# Wisconsin Department of Transportation

**Proposal #03: 1400-00-84, WISC 2021 076  
Columbus - Watertown  
Beaver Dam River Struct B-14-0060  
STH 16  
Dodge County**

This is Addendum No. 01, which provides for the following:

Addendum No. 01  
 ID 1400-00-84  
 Revised Sheet 10  
 January 5, 2021

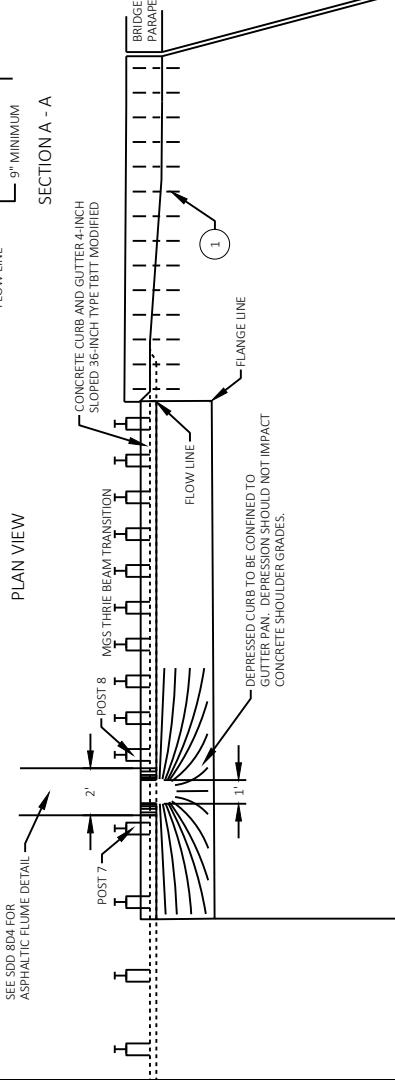
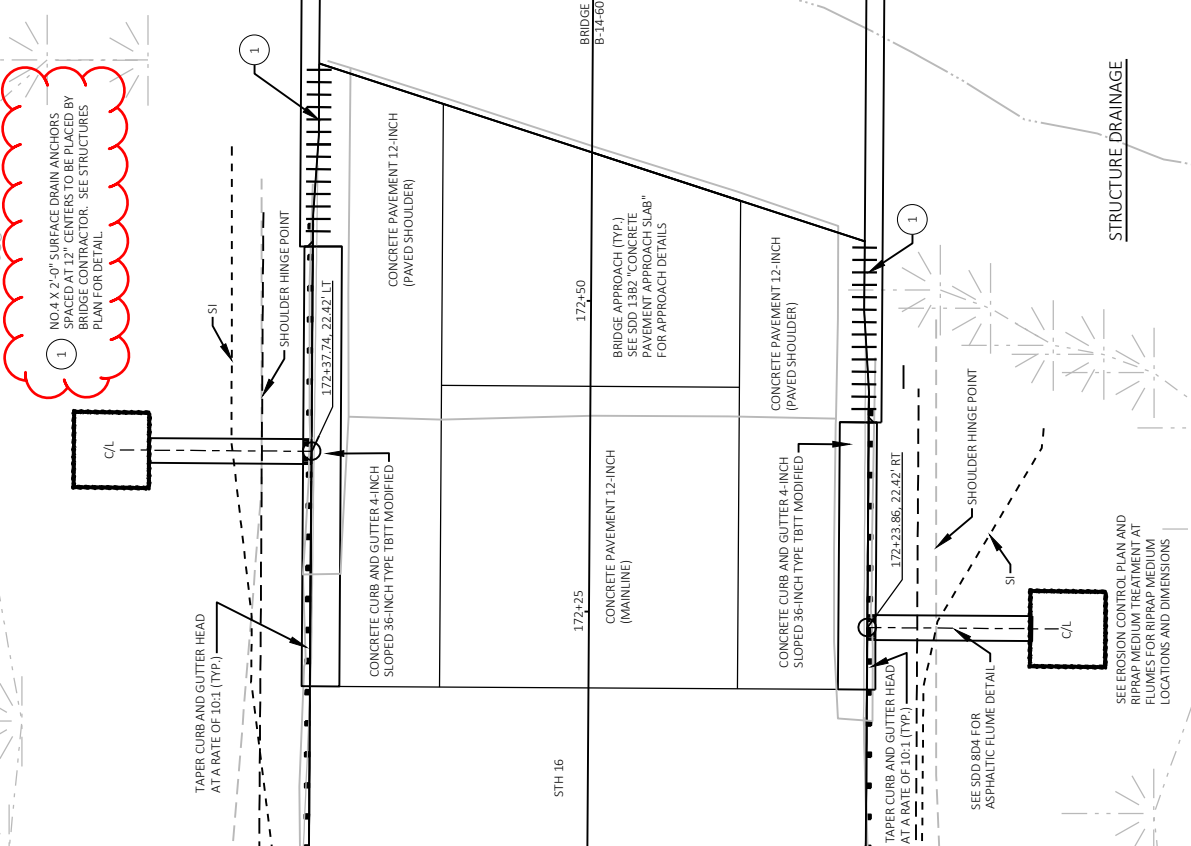
Revised Plan Sheets	
Plan Sheet	Plan Sheet Title (brief description of changes to sheet)
10	Construction Details (revised callout 1 note to replace "tie bars" with "surface drain anchors" the term used in structure plans)
28	Miscellaneous Quantities (delete drilled tie bars item from "Concrete Pavement Item" quantity table, these bars/anchors are included in structure plan quantities)

1 NO.4 X 2'-0" SURFACE DRAIN ANCHORS SPACED AT 12" CENTERS TO BE PLACED BY BRIDGE CONTRACTOR. SEE STRUCTURES PLAN FOR DETAIL.

1 NO.4 X 2'-0" SURFACE DRAIN ANCHORS SPACED AT 12" CENTERS TO BE PLACED BY BRIDGE CONTRACTOR. SEE STRUCTURES PLAN FOR DETAIL.
